MEMORANDUM

PROJECT: Fairland Road Improvements
From Columbia Pike (US29) to Prince George's County
CIP Project No. 509337

REVIEW TYPE: Forest Conservation Plan (No. MR 02813-DPW&T-1)

RECOMMENDATION: APPROVAL WITH CONDITIONS

TREE REMOVAL TO IMPROVE
INTERSECTION SIGHT DISTANCE - BEETHOVEN
EXISTING CONDITIONS - FULL CROSSING

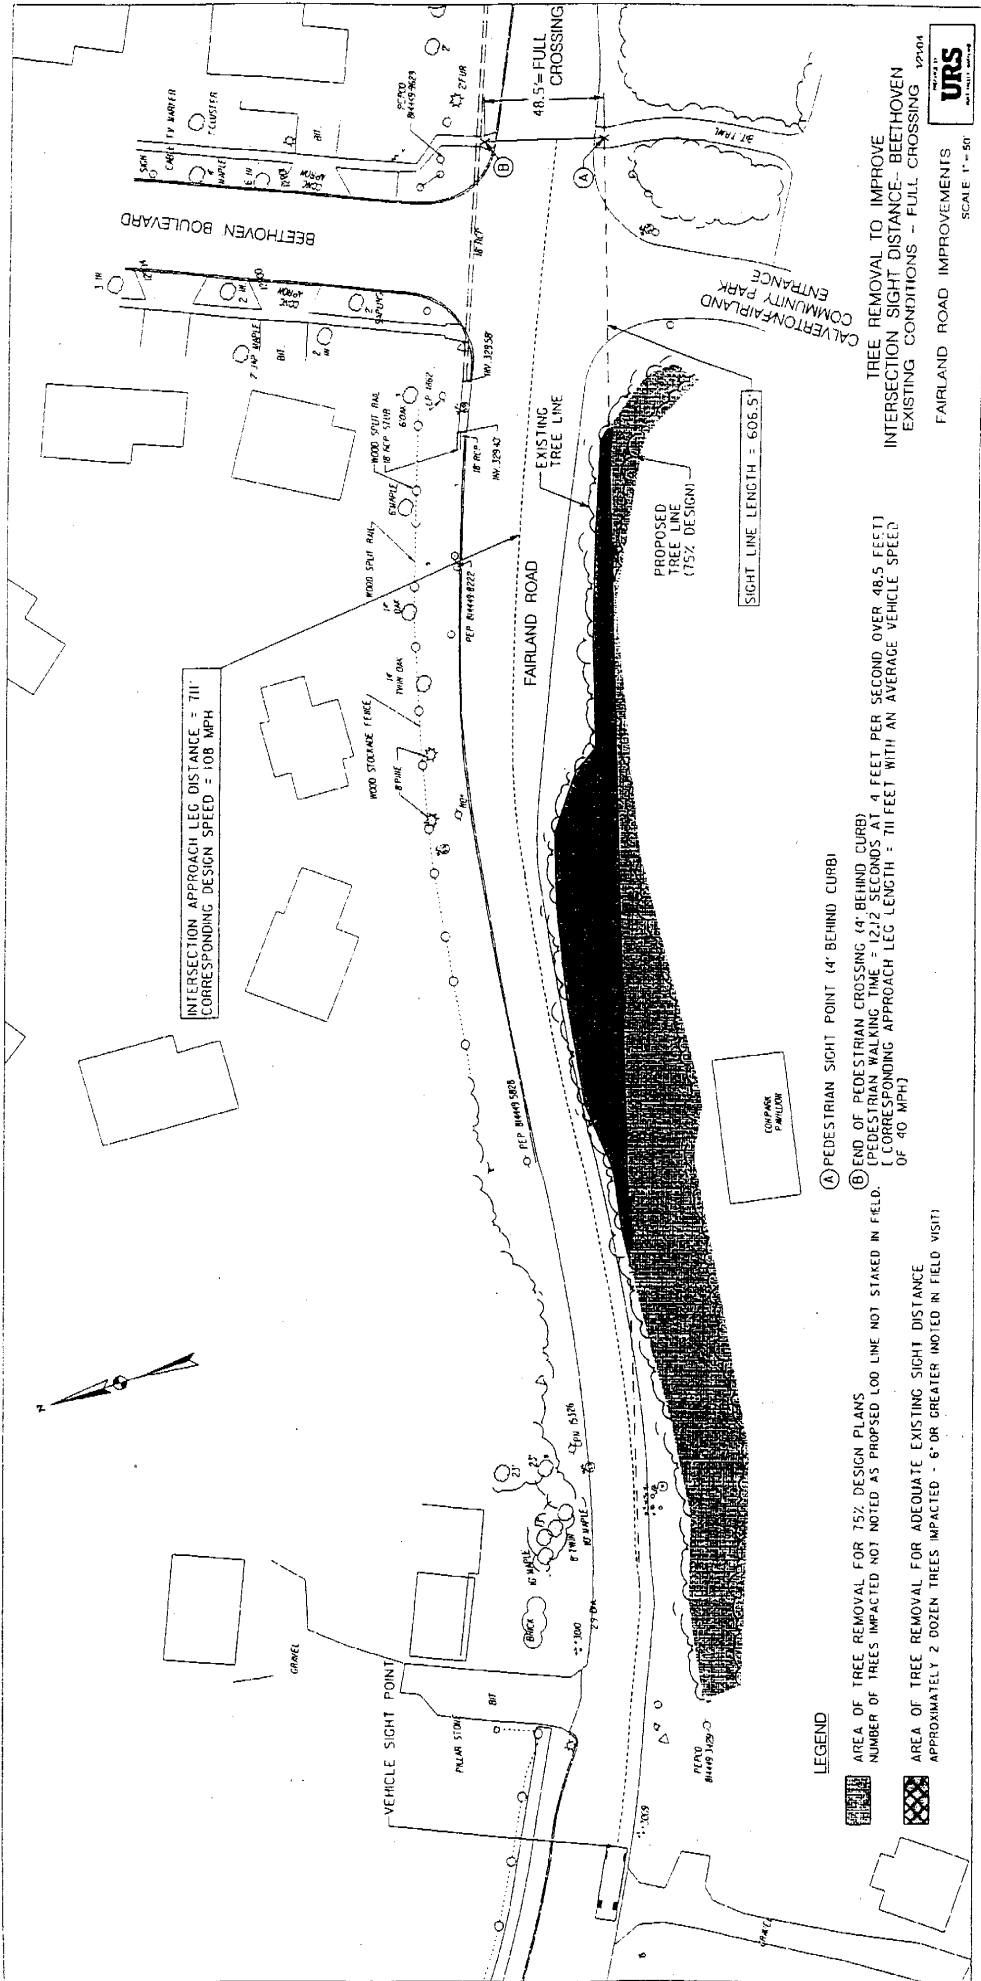
Prior to the start of the road project (e.g. this spring), DPWT intends to remove 40,284 square feet of forest on the south side of Fairland Road along the northern boundary of Calverton-Galway Park property, to improve intersection sight distance to Beethoven Boulevard and thereby improve motorist and pedestrian safety (see attached map). This includes 8,050 square feet on Calverton-Galway Park property. DPWT has submitted a park permit application and plans showing the area of tree removal on park property along Fairland Road. The permit has not been issued because parties agreed that the permit should be withheld pending Planning Board approval of the preliminary FCP. Staff agrees that the additional removal is necessary to address a current traffic hazard and recommends that the FCP, including the proposed forest clearing for immediate safety, be approved with the above conditions.

AREA OF TREE REMOVAL FOR 75% DESIGN PLANS
NUMBER OF TREES IMPACTED NOT NOTED AS PROPOSED L00 LINE NOT STAKED IN FIELD.

AREA OF TREE REMOVAL FOR ADEQUATE EXISTING SIGHT DISTANCE
APPROXIMATELY 2 DOZEN TREES IMPACTED - 6" OR GREATER (NOTED IN FIELD VISIT)
